REPORT #59-88

PLANNING DEPARTMENT REPORT
ASHMONT SREET SUBDIVISION
PETER BASS, APPLICANT

July 12, 1988

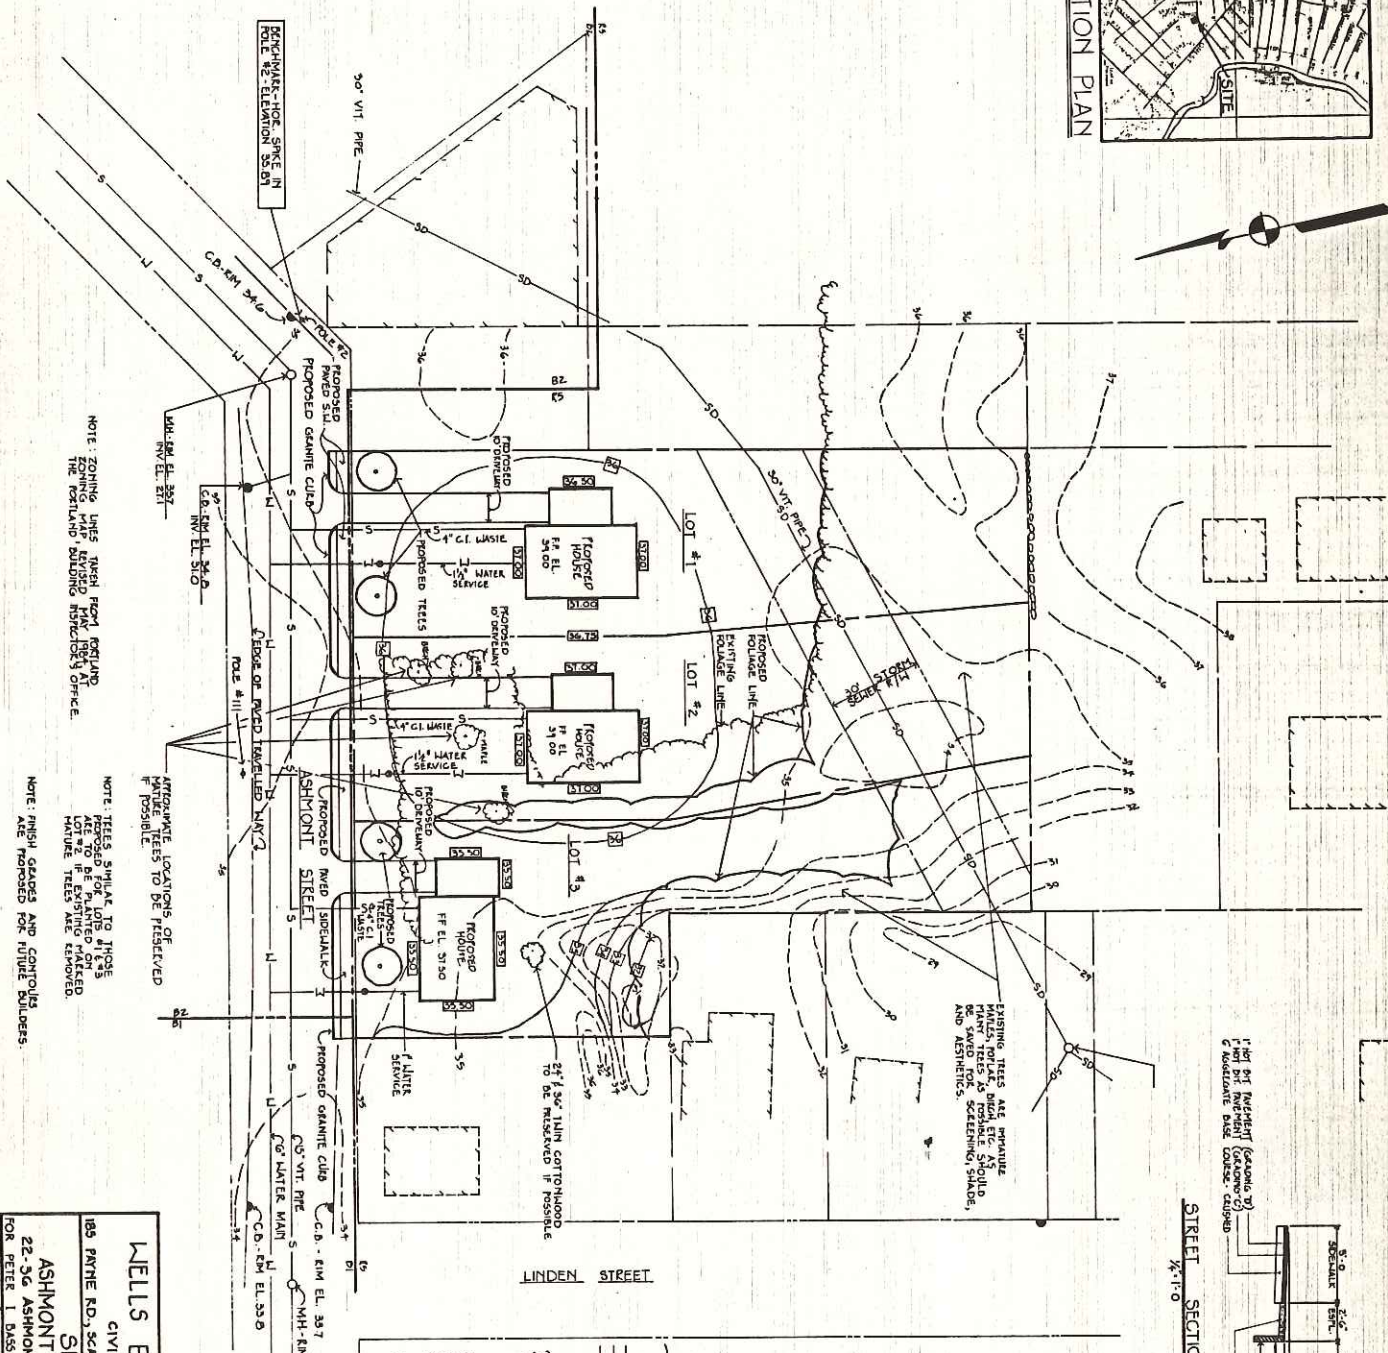
The applicant owns land that is contiguous to the proposed subdivision (East of Lot #1). This parcel should be labeled as a lot with appropriate survey information shown on the recording plat. Some City maps indicate a proposed street running through this parcel. Although it may have been intended as a right of way, it was never recorded for dedication. The property is owned by applicant and is not a dedicated street. See Attachments C, D. The plat indicates that there is a parking easement on this property to the abutting property owner (Forsely) for parking purposes.

The subdivision lots have street frontage along Ashmont Street. The applicant is proposing to install granite curbing and a sidewalk along the street frontage of the three (3) subdivision lots. William Bray, City Traffic Engineer, has reviewed the plan and finds it acceptable provided that the applicant install granite curbing from the Forsely property (where the existing granite curbing ends) to Lincoln Street. Mr. Bray recommends that the curbing not end in mid block so as not to create a hazard to cars or snow plows. This would require an additional 85 feet of curbing.

There is an existing 30 inch storm drain line that crosses the rear part of the property. The City apparently was never given an easement for the storm drain line. As this is connected into the City sewer system, a 30 foot

easement should be provided to the City. The subdivision plan has been labeled accordingly. However, a drainage easement document should be submitted for review and approval by Corporation Counsel and Parks and Public Works. Comments of the City Planning Engineer are attached (see Attachment H).

The plan indicates the intent of saving existing mature trees on the site. However, the plan should specify that a minimum of two trees per lot in the front yard shall either be planted or conserved and meeting the "Aboricultural Specifications and Standards of Practices of the City of Portland Technical and Design Standards, and Guidelines".

1. That the recording plat shall include adjacent land owned by the applicant. This parcel shall be numbered as a lot with the appropriate survey information.
2. Comments of the City Traffic Engineer regarding curbing along Ashmont Street (see page 2).
3. That an easement for the 30 inch storm drain be submitted for staff review and approval.
4. Comments of the Planning Engineer regarding the storm drain catch basin (see Attachment H).
5. That a minimum of two trees be conserved or planted in the front yard of each lot meeting the City Technical and Design Standards, and Guidelines.

EXISTING DRAINAGE PATTERNS

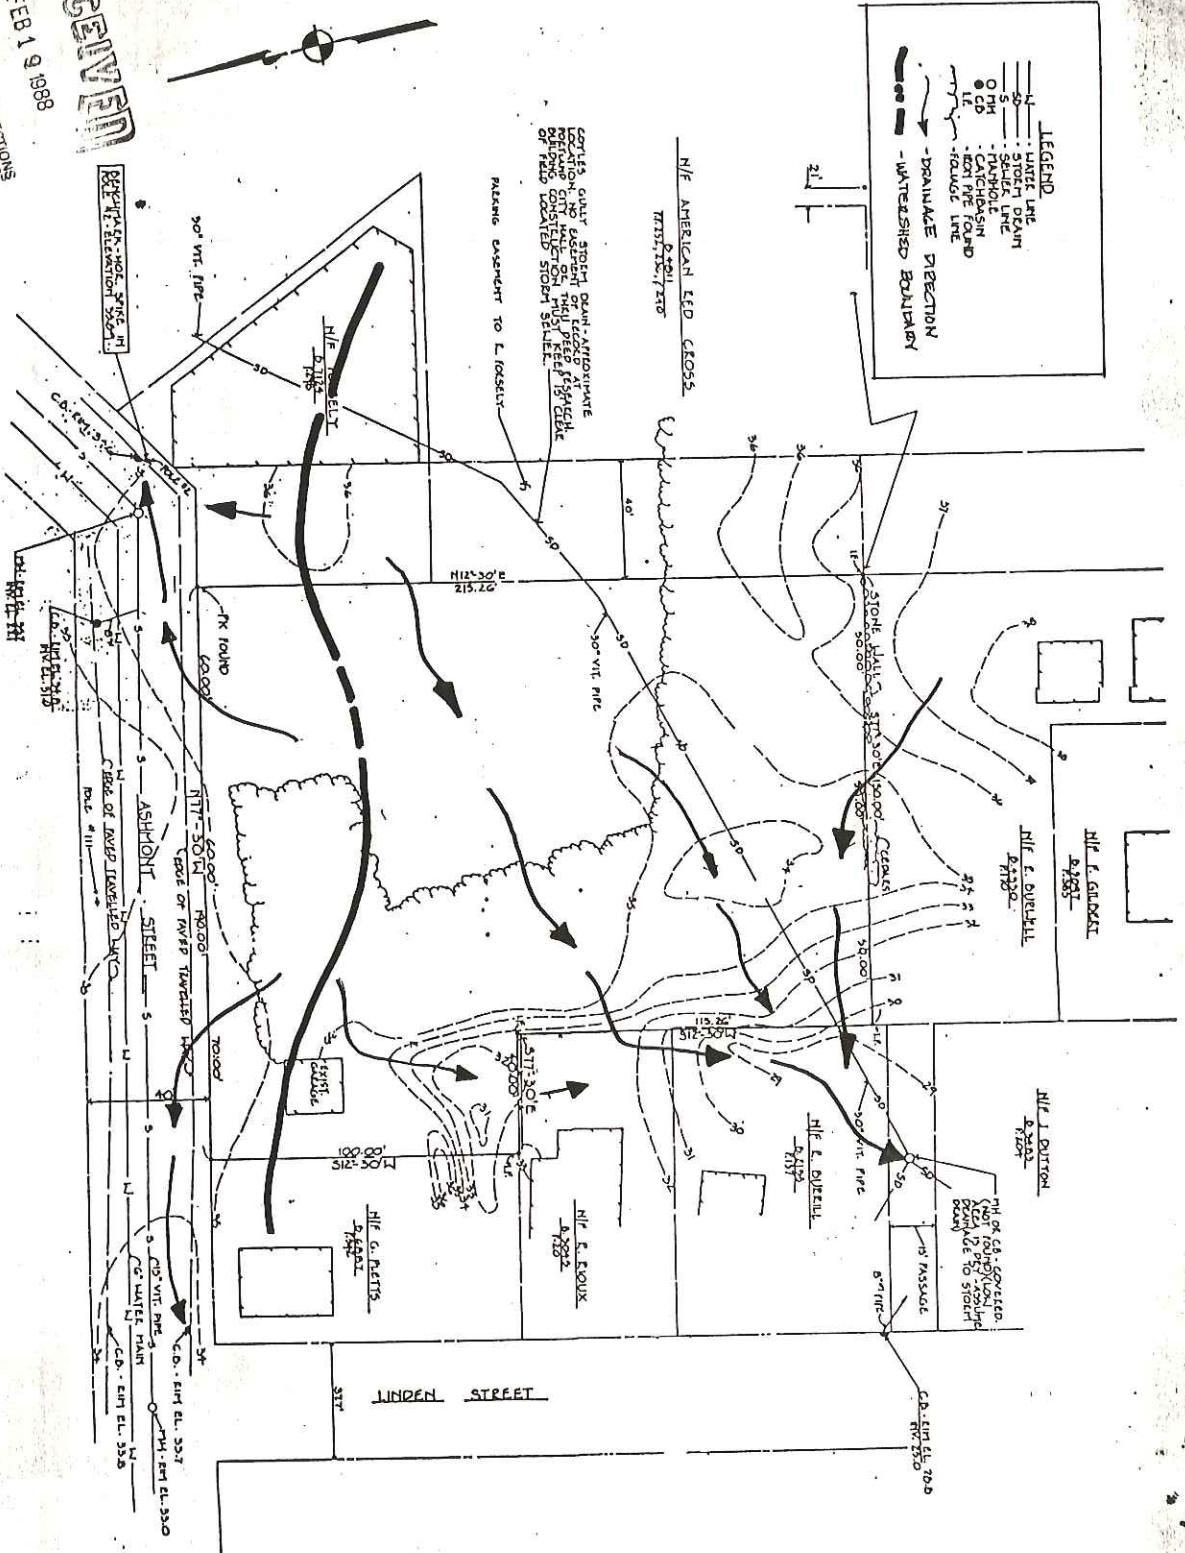
Except for a small area along Ashmont Street, most of the storm water on the site flows to the rear of the parcel, southerly of the Burrill property. An existing drainage structure could provide an outlet for the storm water but it is apparently covered. The drainage structure should be returned to a functioning condition as part of the subdivision improvements.

The applicant has submitted drainage plans indicating the exusting and proposed drainage flows on the site (see Attachment F, G). The basic drainage patterns of the site will remain unchanged.

The proposed subdivision plan is acceptable provided that the catchbasin to the rear of the site is uncovered, repaired and/or replaced. The repair or replacement of the inlet structure shall be approved by the City Engineer and/or designee.
